2130-03-20190  
June 23, 2003

Oyster Creek Generating Station  
Facility Operating License No. DPR-16  
NRC Docket No. 50-219

**Subject:** Response to Request for Additional Information Concerning the Fourth Ten-Year Interval Inservice Inspection Program

DIAGRAM A

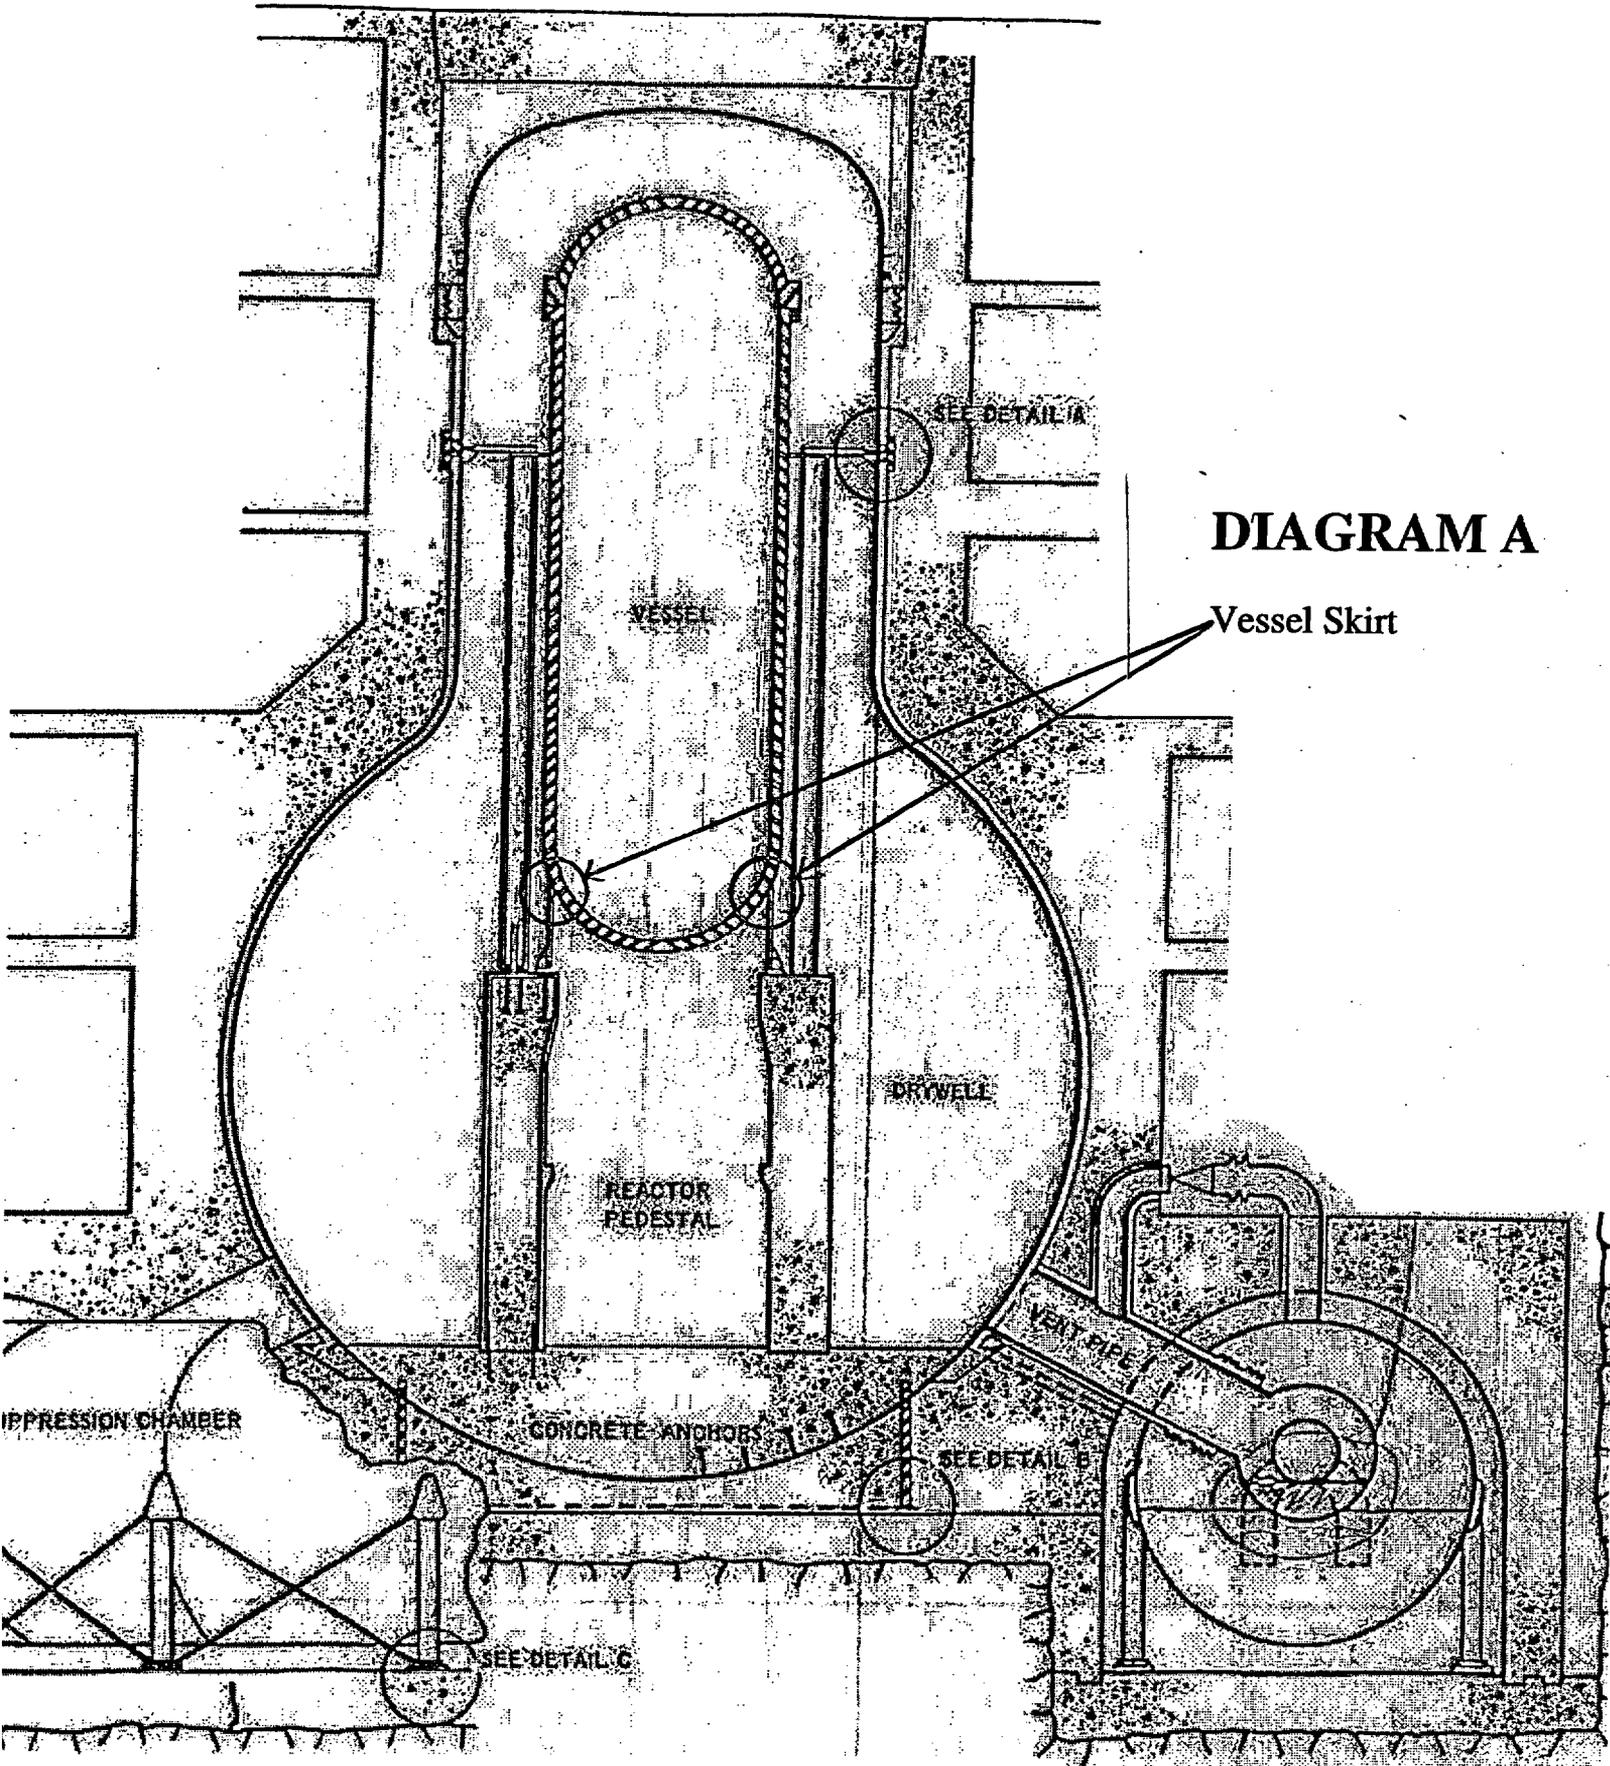
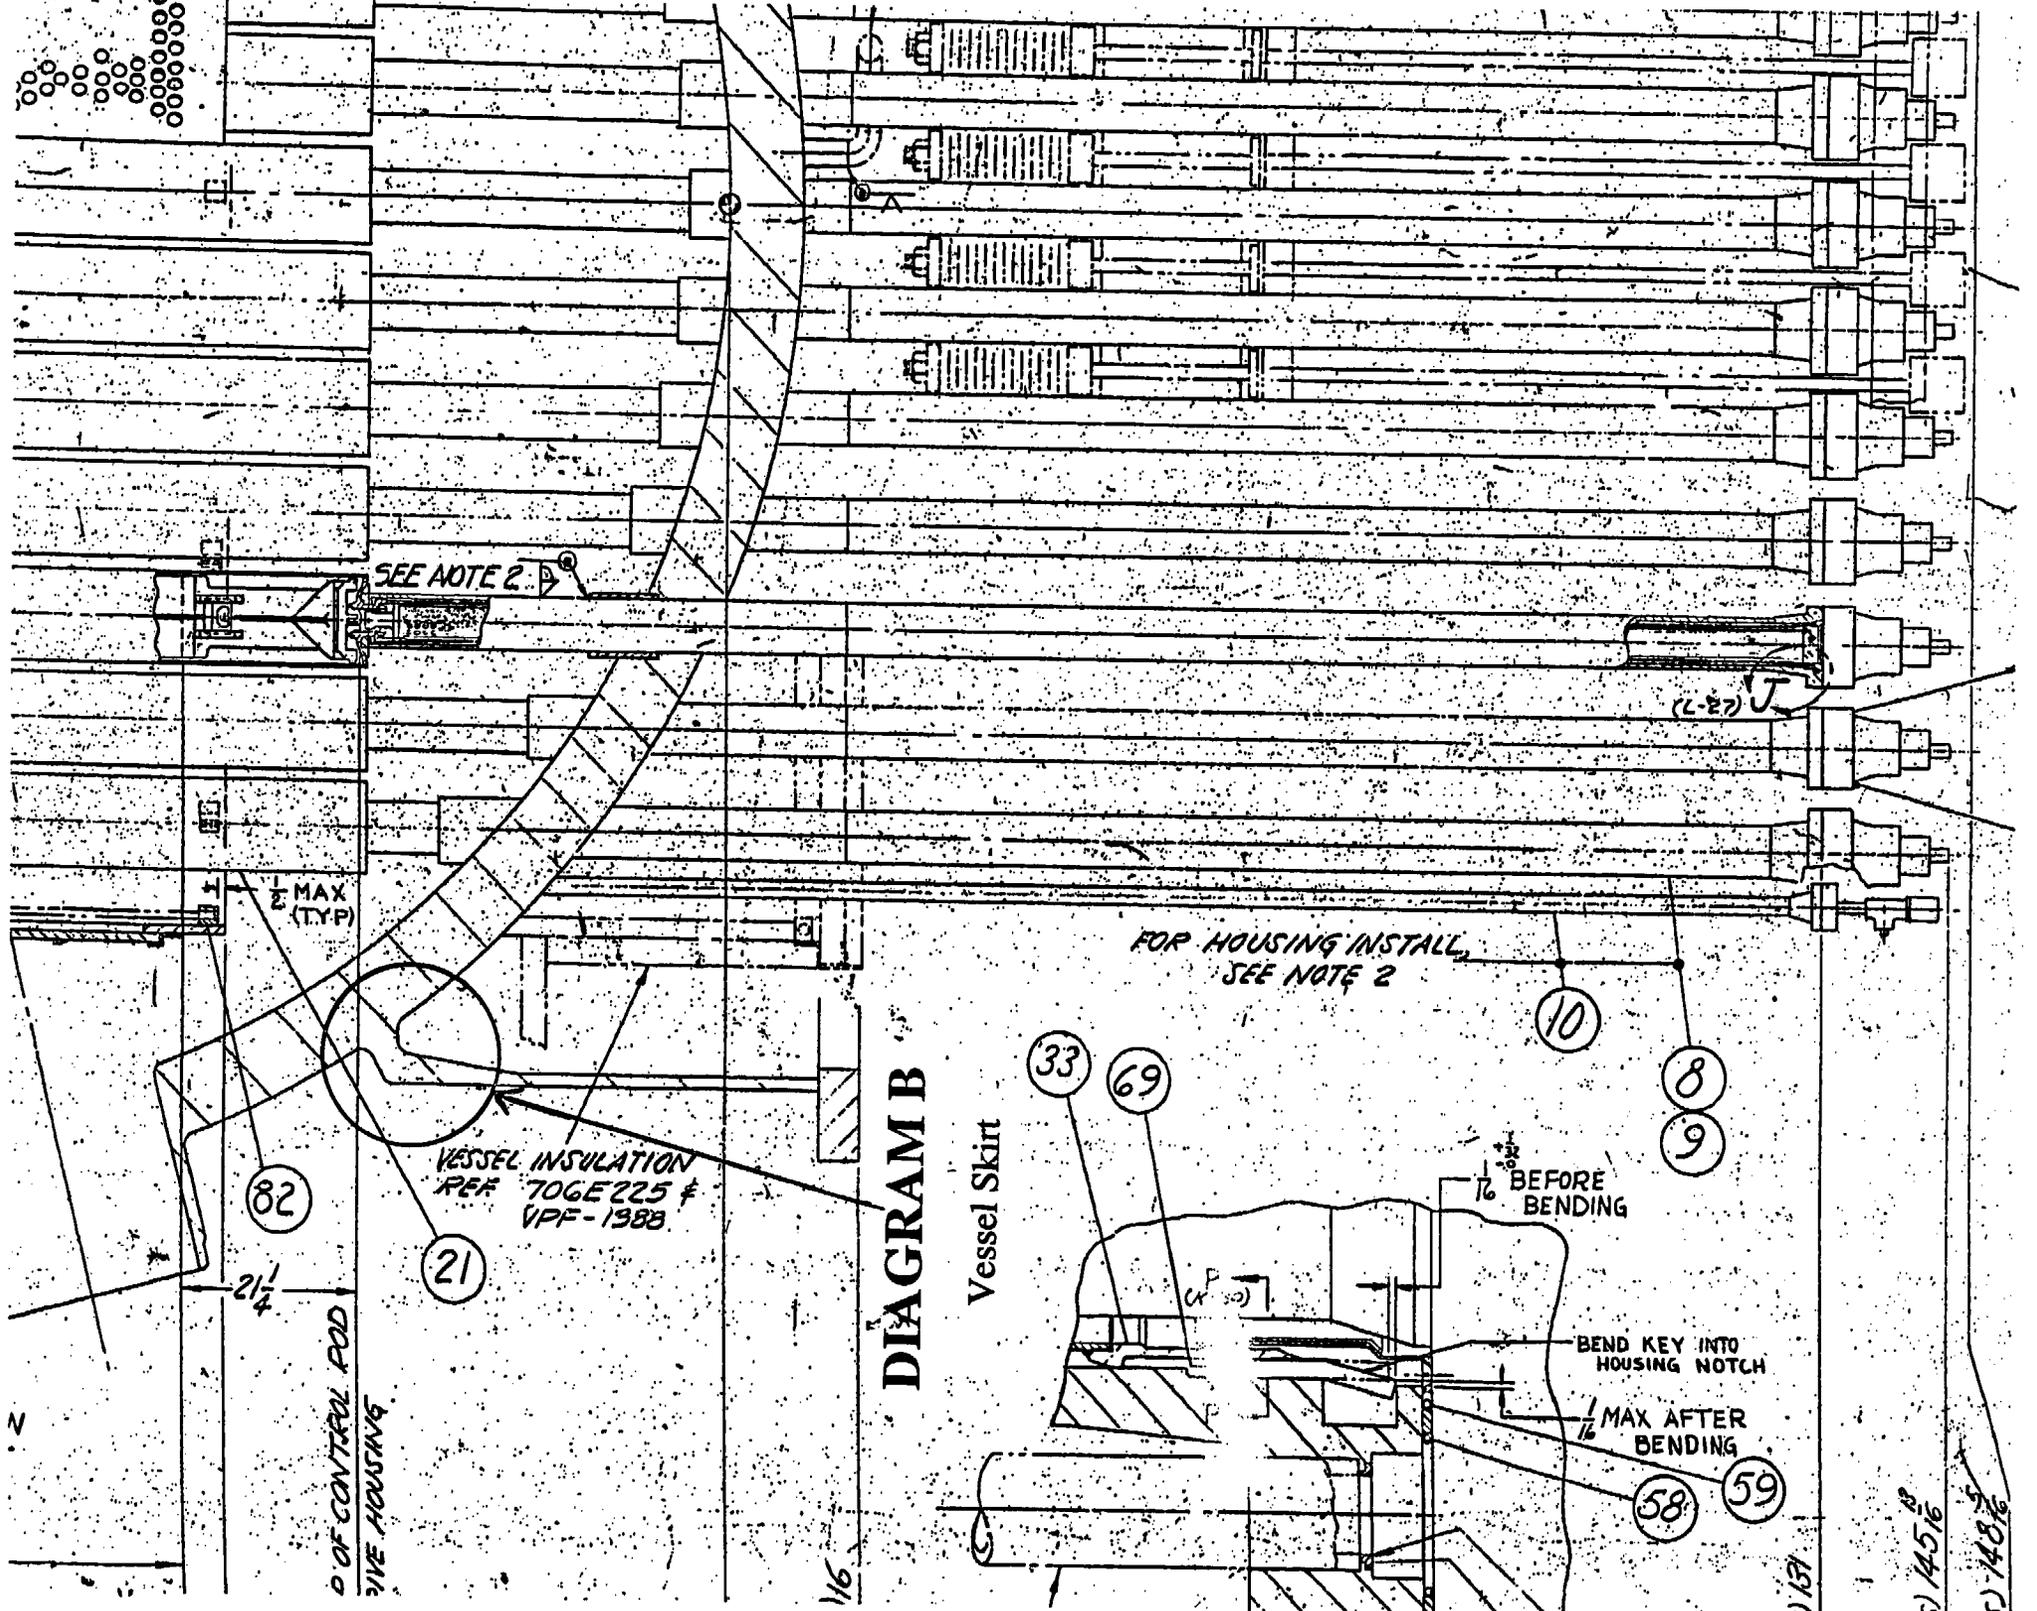
A typical configuration as shown in Figure IWB-2500-13 has been presented. However, the licensee has not provided sufficient detail to demonstrate the impracticality of the surface examinations, due to these specific interferences at Oyster Creek. Please provide, through drawings or sketches, photographs, or more detailed technical descriptions, further information to support a determination of impracticality. Include in this information the variables that produce the surface examination limitations with respect to magnetic particle or liquid penetrant testing.

The licensee argued that their nondestructive examination group pursued the use of an alternative ultrasonic method in lieu of the required surface examinations on the inside surface area C-D of Weld 1-569. The licensee concluded that, due to the unique configuration of the Oyster Creek RPV skirt design, an ultrasonic examination would not provide Code examination coverage. However, no physical description or other

component specific information has been provided to support this conclusion. The Staff notes that other licensee's with typical RPV skirt weld configurations have applied ultrasonic methods to examine all or large percentages of the Code-required surface areas. Please provide sufficient information to enable the Staff to determine whether ultrasonic techniques may be applied at Oyster Creek.

The licensee stated, as part of their alternative examination, that Oyster Creek will "perform a VT-3 visual examination of the support skirt IWB boundary as shown in Figure IWB-2500-13 for any support deformation." It is unclear whether the VT-3 visual will be conducted as a direct, or remote, inspection, and whether the IWB boundary is intended to include the surface areas A-B and C-D, as described in Figure IWB-2500-13. It is also unclear what is meant by the phrase "any support deformation." Please clarify.

The support skirt does not contain personnel access holes or inspection ports that would allow examination of the C-D surface area to the extent required by the Code. Attached Diagram A provides a view of the Oyster Creek vessel and the location of the vessel skirt. As discussed in our relief request, control rod drive housings and incore housings restrict access for examination of area C-D. Diagram B shows the location of the skirt, and as shown on Diagram B, no access points are provided for examining area C-D. Diagram C provides a closer view of the skirt and refers to Detail "E" which is shown in Diagram D. As discussed in the relief request, an ultrasonic examination was considered as an alternative, but as shown on Diagram D, the 1 1/2 inch radius demonstrates the limited capability to perform this type of exam. As discussed in the relief request, as an alternative to the code requirements, AmerGen proposed to perform a surface examination of area A-B, and perform a VT-3 visual examination of the IWB boundary as shown in Figure IWB-2500-13 of the relief request. This examination would inspect for support member degradation, which includes surface indications or defects.
